Access Compliance Report

Public Rights-of-Way

(Curb Ramps)

Intersection ID: 10024552	Main Street: D_DUCKS_LN	Cross Street: N/A	Location: NE
ADA ID: 4D2D86DD7B83	Ramp Type: PerpDiag	Initial Pass/Fail: Fail	Overall Compliance: No
		Severity Score: 22.5

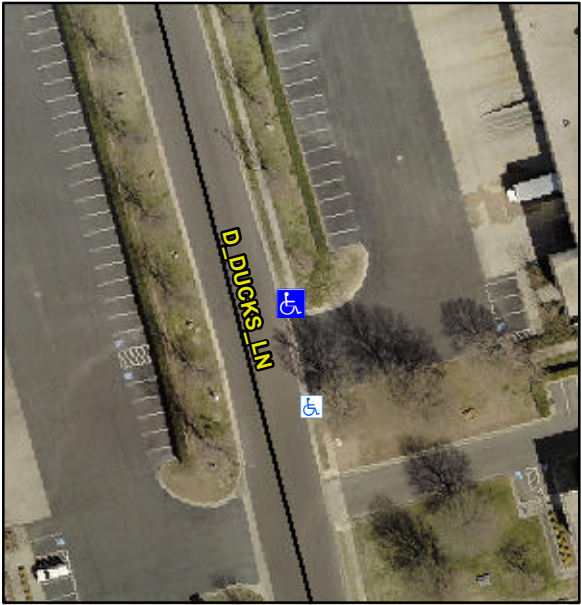
Codes/Mitigation Info/Possible Solution			Field Measurements/Component Compliance		
	Possible Solutions:		Compliance	Description	Data
	Remove & Replace Curb Ramp With Two New Directional Ramps or Equivalent.		No	Ramp Length (in)	46.0
			No	Ramp Width (in)	42.0
			N/A	Flare Type LT	N/A
			N/A	Flare Slope LT (%)	N/A
			N/A	Flare Traversable LT?	N/A
			N/A	Landing Length (in)	N/A
			N/A	Landing Width (in)	N/A
			N/A	Landing Slope (%)	N/A
			N/A	Landing X Slope (%)	N/A
			N/A	Landing Curb? (Y/N)	N/A
			N/A	Shared Landing?	N/A
			N/A	Gutter Ponding?	N/A
			N/A	Gutter Lip Ht (in)	N/A
			No	Painted X Walk1?	No
				X Walk 1 Direction	To W
			N/A	X Walk 1 Width (in)	N/A
				X Walk 1 Slope (%)	1.2
				X Walk 1 X Slope (%)	0.3
			N/A	Ramp inside XWalk1?	N/A
<p>Surveyor Notes:</p> <p>N/A</p> <p>PROW/ADA:</p> <p>R304.5.1, R304.2.2, R304.5.3</p>			N/A	Flare Type RT	N/A
			N/A	Flare Slope RT (%)	N/A
			N/A	Flare Traversable RT?	N/A
